Product / Process Change Notification (PCN)

PCN #: PCN_ConWTB254_20190222
Affected Series: WE-ConWTB254
 6190xx19521 6190xx11021 6190xx11121
PCN Date: January 22, 2019
Effective Date: February 22, 2019

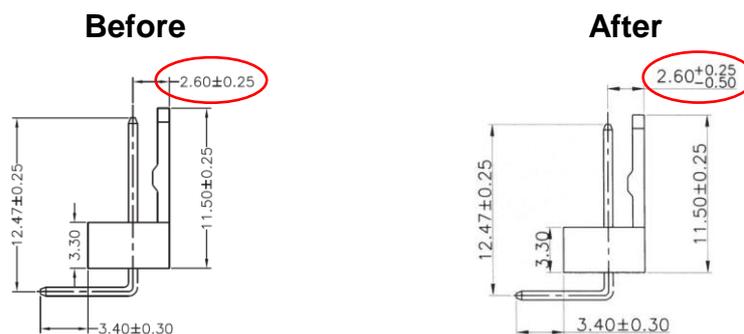
Because of a database mismatch, Würth Elektronik will change the tolerance of the dimension between the pin and the housing.

The tolerance of the dimension 2.60 will increase from ± 0.25 to $+0.25/-0.50$.
